# INNER WEST COUNCIL

## DEVELOPMENT ASSESSMENT REPORT

<b>Application No.</b>	D/2018/205
<b>Address</b>	10 Montague Street, BALMAIN NSW 2041
<b>Proposal</b>	Alterations and additions to existing dwelling-house, including two storey rear addition, and associated works, including on-site parking, new shed, new fencing and tree removal.
<b>Date of Lodgement</b>	23 April 2018
<b>Applicant</b>	Oikos Architects
<b>Owner</b>	J. W. Ryan
<b>Number of Submissions</b>	One (1)
<b>Value of works</b>	\$450,000
<b>Reason for determination at Planning Panel</b>	Proposal requires pruning of three (3) Council's street trees in Llewellyn Street
<b>Main Issues</b>	<ul style="list-style-type: none"> <li>• Pruning Council heritage listed street trees</li> <li>• Solar access – 12 Montague Street</li> <li>• Privacy concerns - 34 Llewellyn Street</li> </ul>
<b>Recommendation</b>	Approval
<b>Attachment A</b>	Recommended conditions of consent
<b>Attachment B</b>	Plans of proposed development

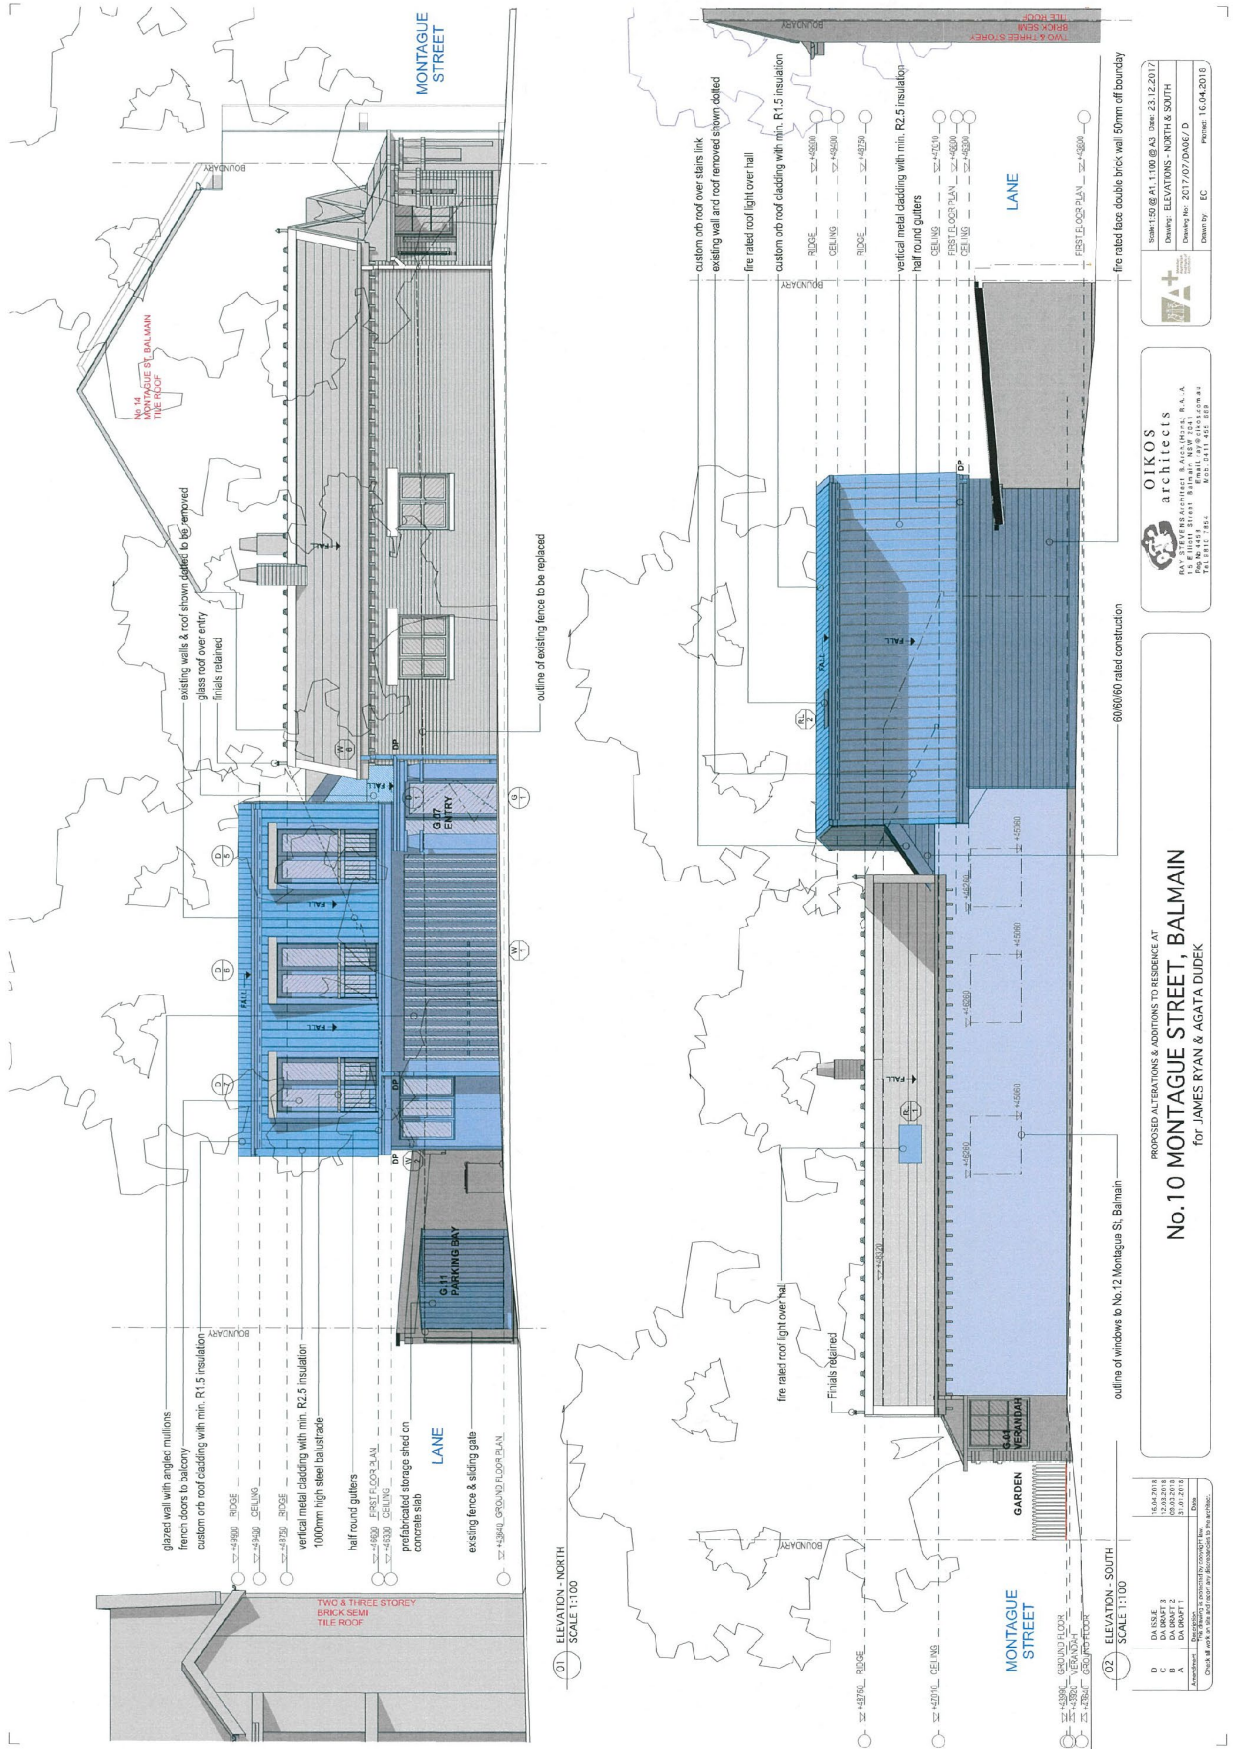
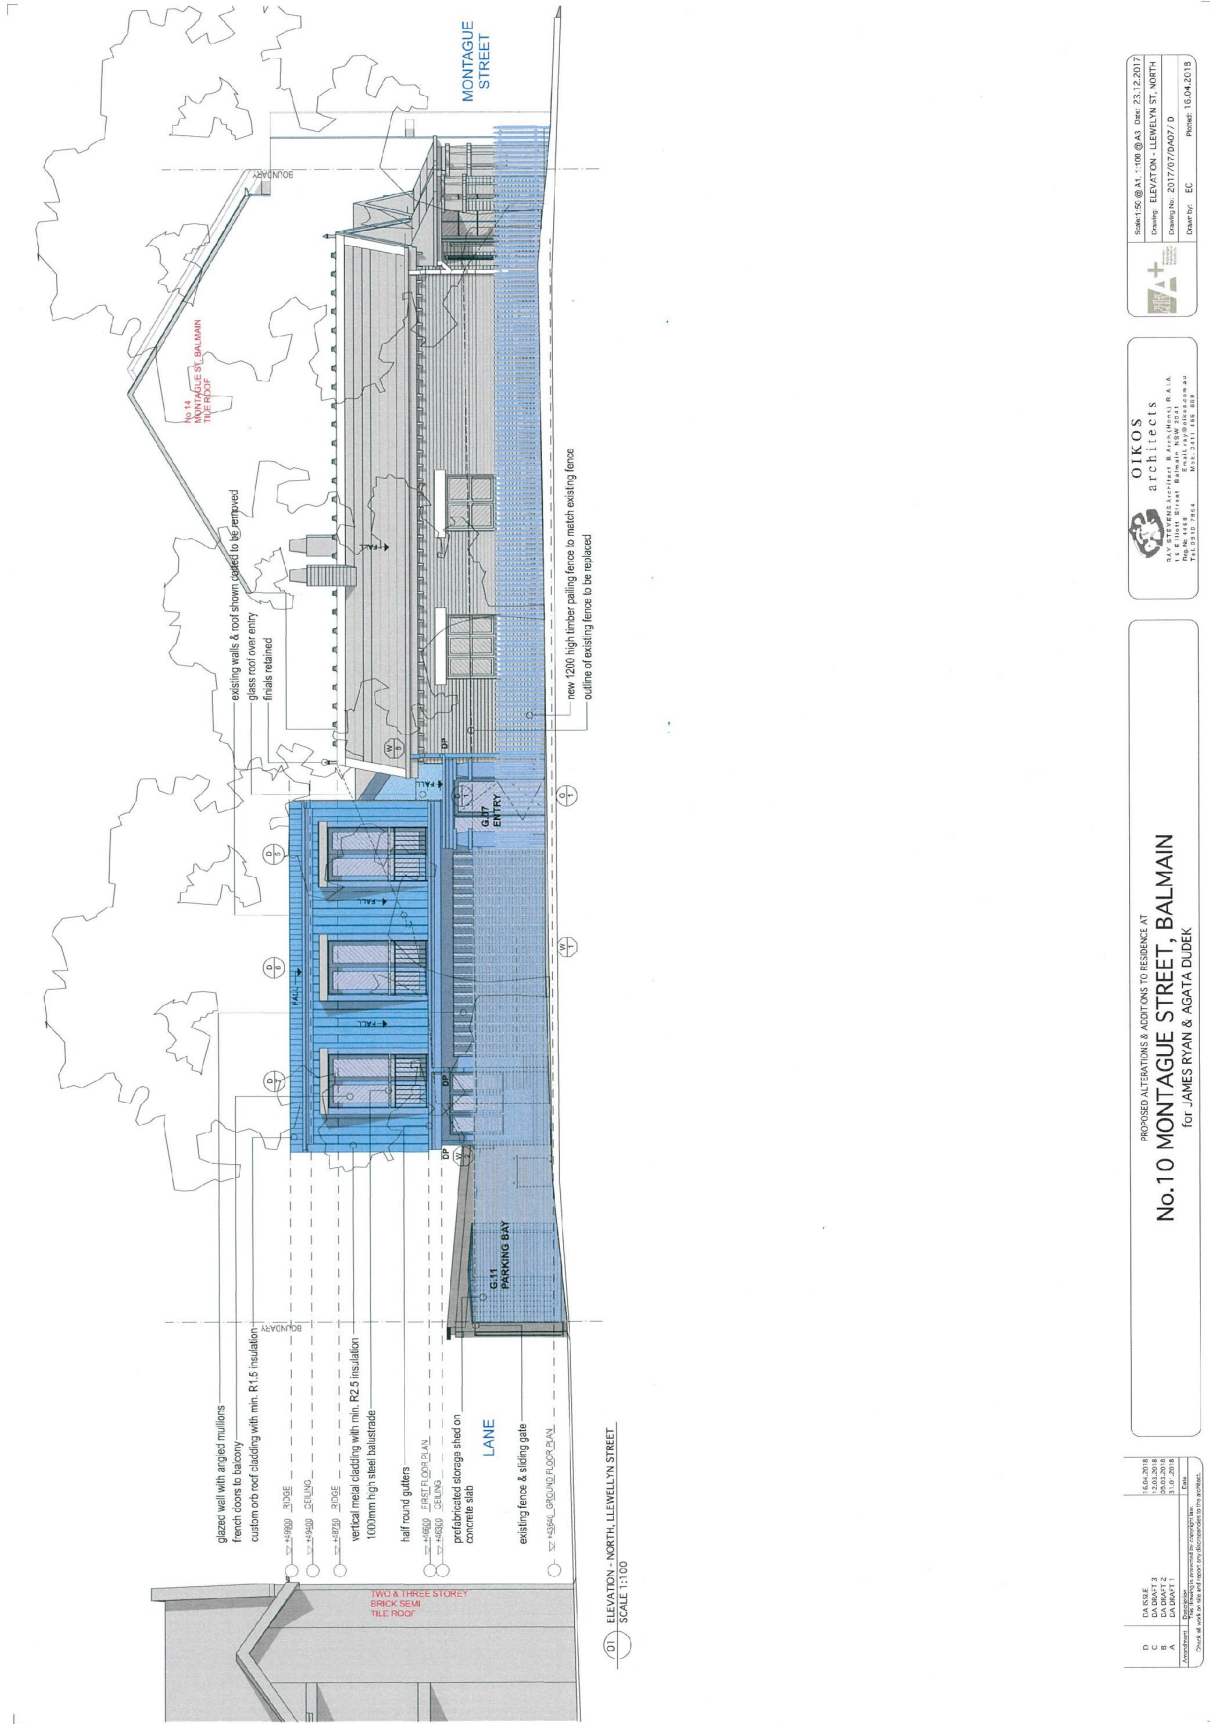
- window W8 on the northern elevation of the internal stairway from the ground floor to the first floor being deleted; and
- the stair link connecting the ground and first floors be relocated or realigned to project only from the eastern, rear facing roof plane and the southern roof plane and associated capping being kept intact.

- window W8 on the northern elevation of the internal stairway from the ground floor to the first floor being deleted; and
- the stair link connecting the ground and first floors be relocated or realigned to project only from the eastern, rear facing roof plane and the southern roof plane and associated capping being kept intact.

8.	<p>Amended plans are to be submitted incorporating the following amendments to protect the heritage qualities of The Valley Heritage Conservation Area:</p> <ul style="list-style-type: none"> <li>a) Window W8 on the northern elevation of the internal stairway from the ground floor to the first floor is to be deleted.</li> <li>b) The stair link connecting the ground and first floors shall be relocated / realigned to project only from eastern, rear facing roof plane. As a consequence of this change, the southern roof plane and associated capping are to be kept intact.</li> </ul> <p>Details demonstrating compliance with the requirements of this condition are to be marked on the plans and be submitted to the Principal Certifying Authority's satisfaction prior to the issue of any Construction Certificate.</p>
